Docket Nos. 50-280
and 50-281

Licenses Nos. DPR-32
and DPR-37

Change No. 12

6.1 ORGANIZATION, SAFETY AND OPERATION REVIEW

TS FIG. 6.1-1
 SEP 19 1973

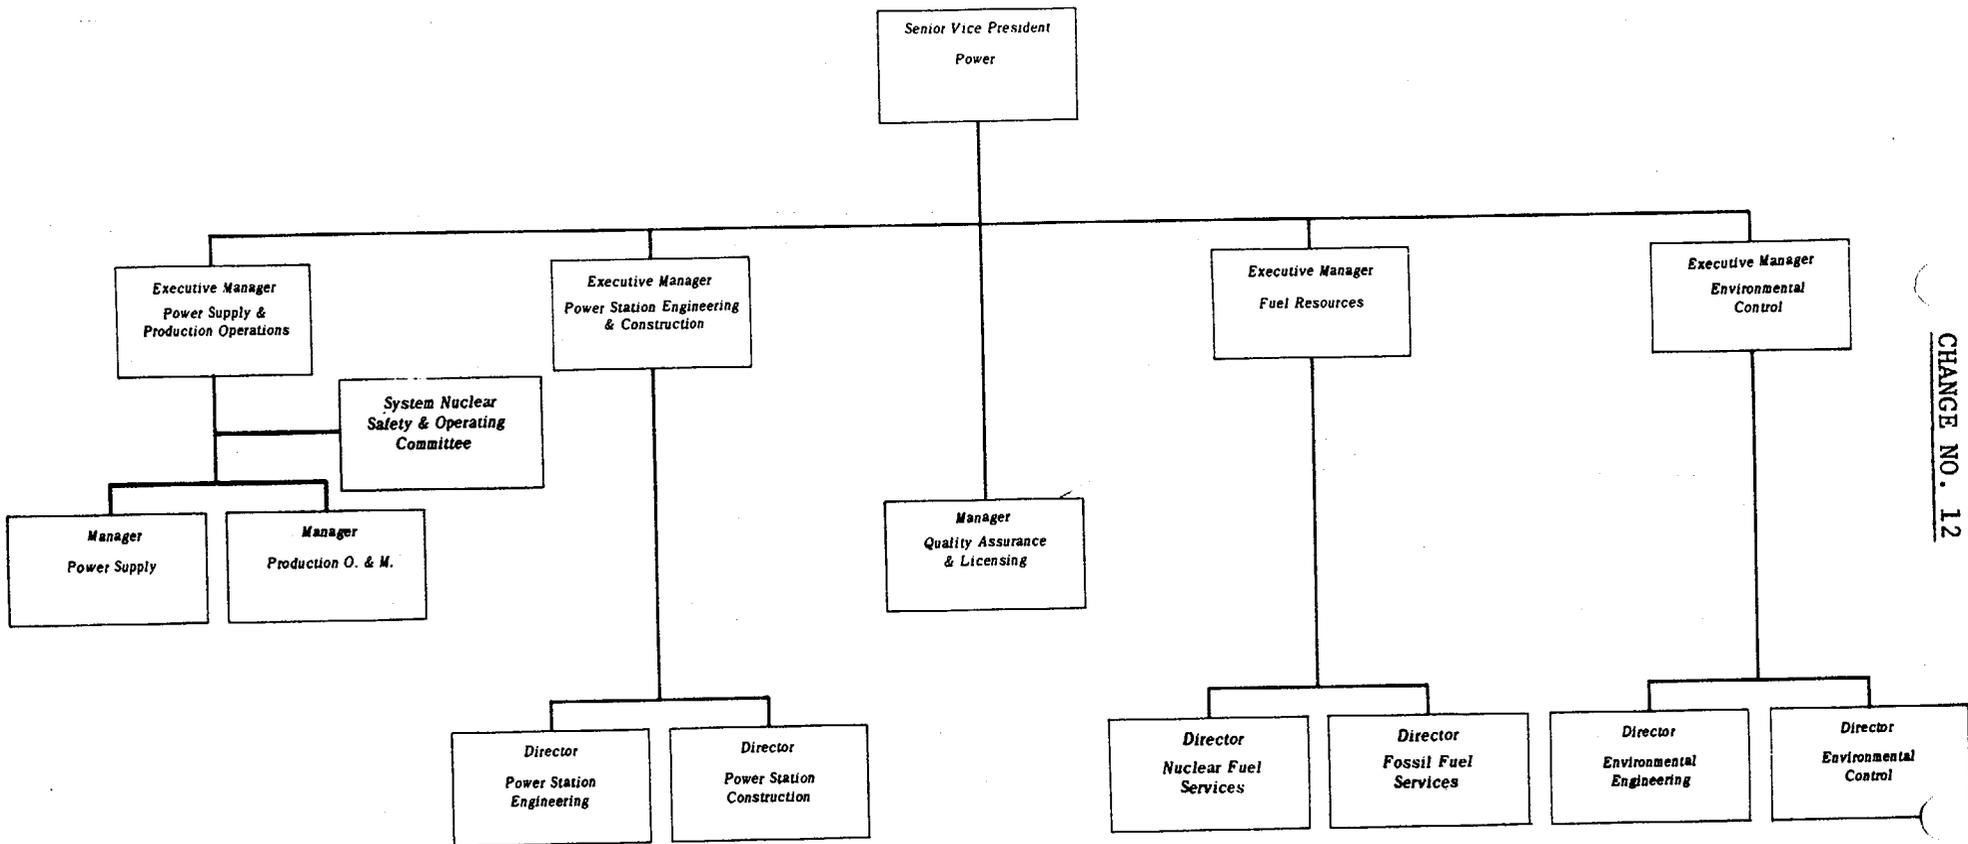
Your letter dated August 15, 1973, enclosed proposed changes in Section 6.1, "Organization, Safety and Operation Review"; Section 6.2, "Action to be Taken in the Event of an Abnormal Occurrence in Station Operation"; Section 6.3, "Action to be Taken if a Safety Limit is Exceeded"; and Section 6.4, "Unit Operating Procedures" of the Technical Specifications for Facility Operating Licenses Nos. DPR-32 and DPR-37 for Surry Power Station Units 1 and 2. The proposed changes would update Virginia Electric and Power Company's management and operating organization, reporting procedures to reflect recent organizational changes, expand the System Nuclear Safety and Operating Committee, and correct a typographical error.

We have reviewed the proposed changes in the Virginia Electric and Power Company management structure which reflect recent reassignments of management and reporting procedures. We have determined that the proposed changes do not adversely affect the management of reactor operations; therefore, the changes are acceptable.

A. The Station Manager shall be responsible for the safe operation of the facility. The Station Manager shall report to the Manager Production Operation and Maintenance. The relationship between this Manager and other levels of company management is shown in TS Figures 6.1-1, 6.1-2, and 6.1-3.

TS FIG. 6.1-4
 SEP 19 1973

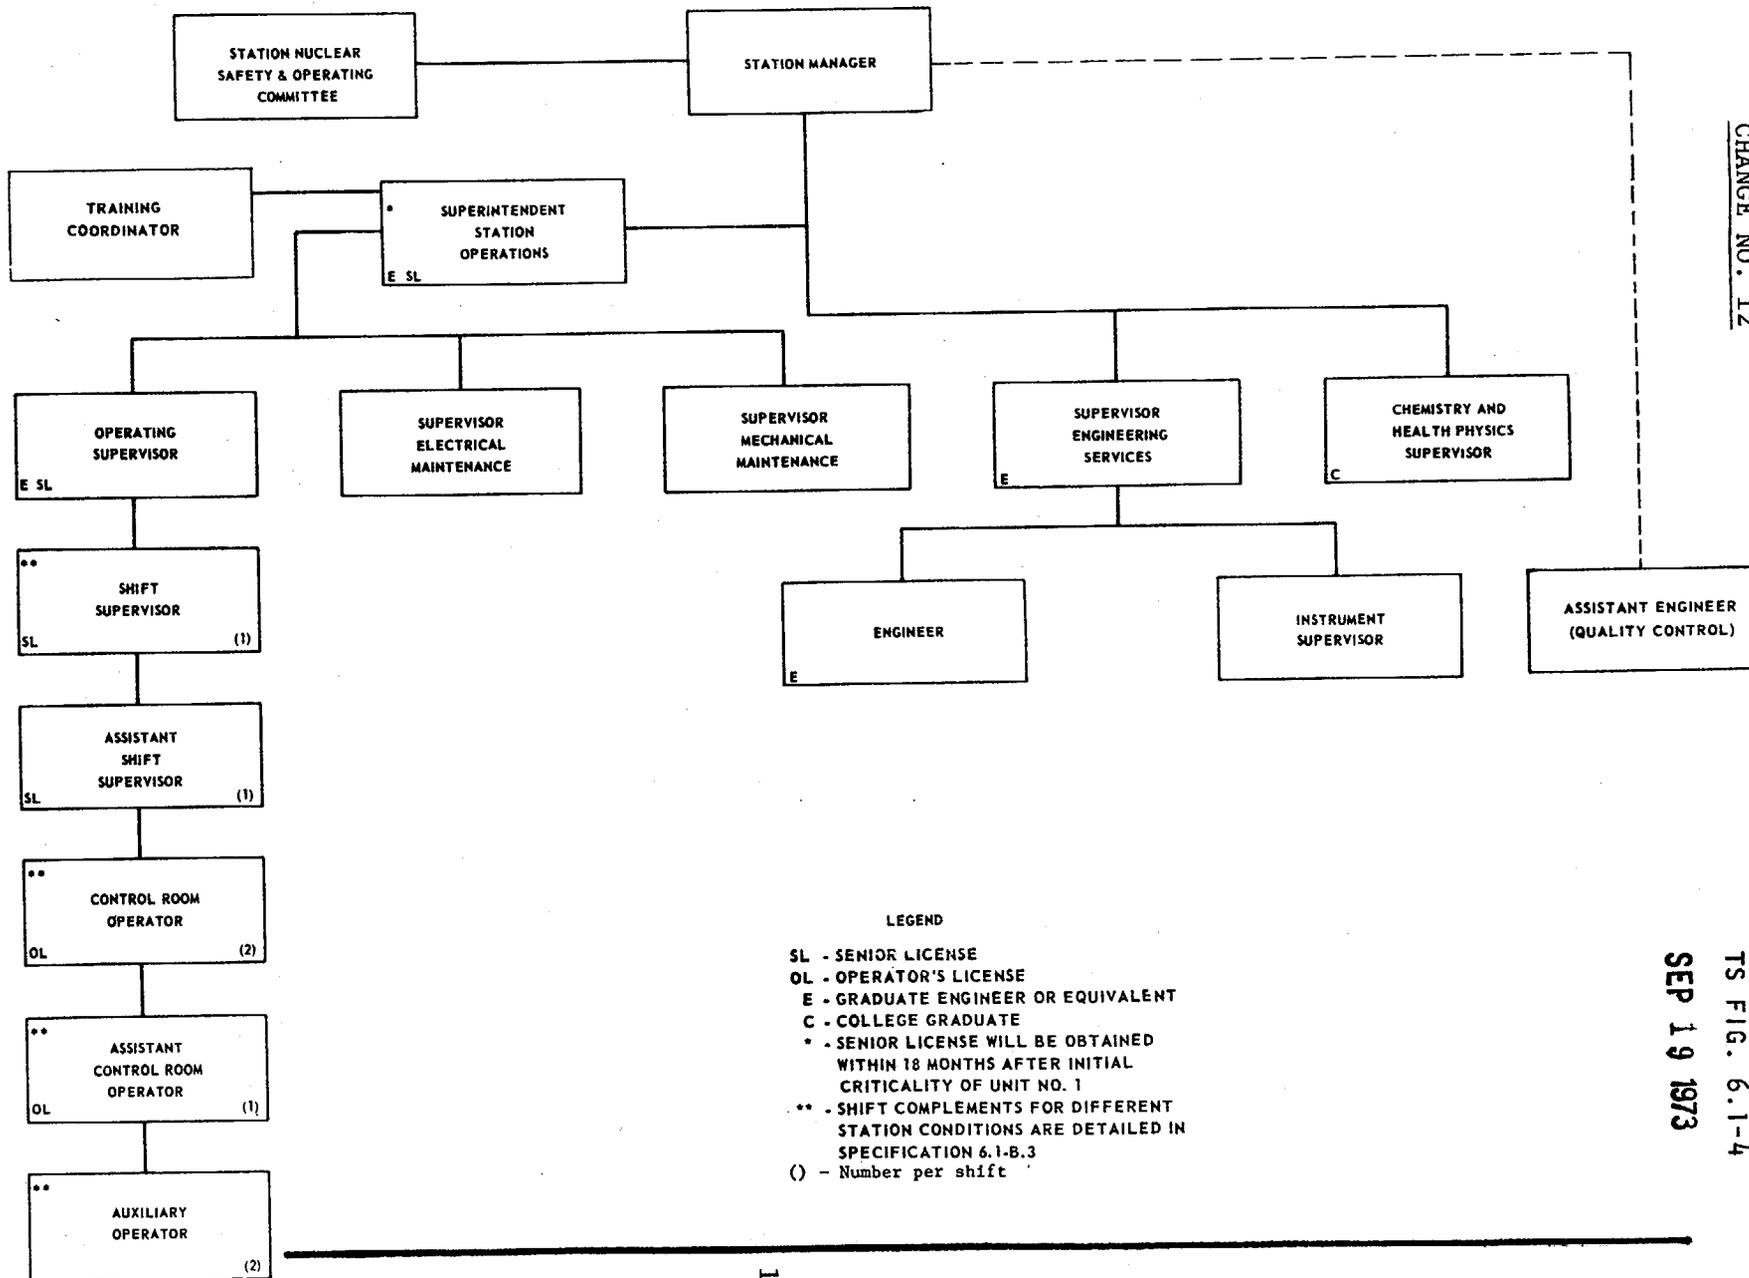
B. The station organization shall conform to the chart as shown in TS Figure 6.1-4.
